Access Compliance Report Public Rights-of-Way (Curb Ramps)

Main Street: AIROSO_ST Cross Street: CHIQUITA_CANYON_DR Location: E

ADA ID: RPRK211124130712 Ramp Type: Type 1 - Perpendicular Initial Pass/Fail: Fail Overall Compliance: No Severity Score: 2

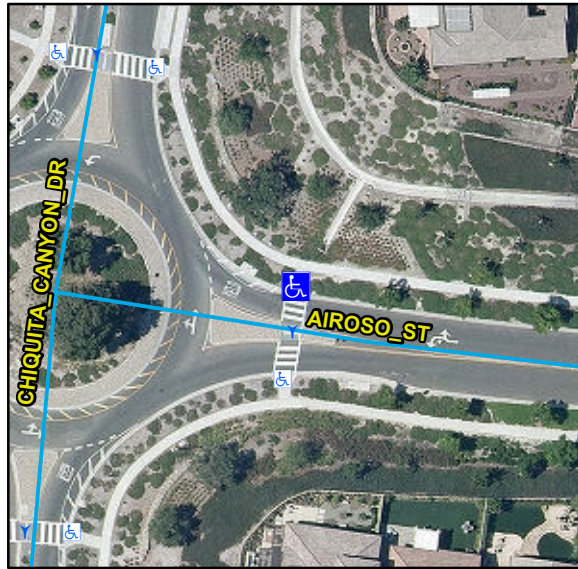
Surveyor Notes:

N/A

Possible Solutions:

Remove & Replace Entire Ramp.

OC Std/PROW:

R304.2.2, R304.5.3, STD 1115
